Survey Undertaken By Peter Evans
London Overground Rail Operations Ltd

5887 PLATFORM END SECURITY SYSTEMS

Camden Road

Monday, 31 October 2016

ISSUE 2 STRATFORD END OF PLATFORM NO2

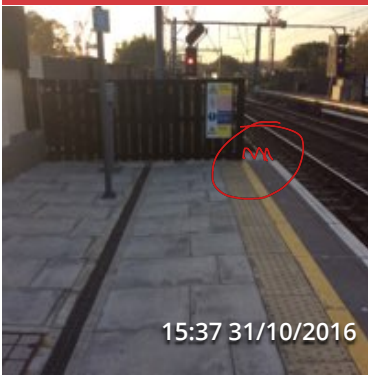
Install wooden fence with gate and anti trespass panel as shown

The fence and gate would match up with the fence/gate at the other end of platform

If larger gaps in the vertical rails are required this could be accommodated provided the gaps are no wider than 100mm

A metal fence would need to be earth bonded due to the close proximity of the overhead wires and touch potential between the fence and trains. There would be a considerable amount of cabling and obviously the route for these would need to be approved by your good-selves

The existing palisade fence is not earthed as it is so far away from overhead lines and trains
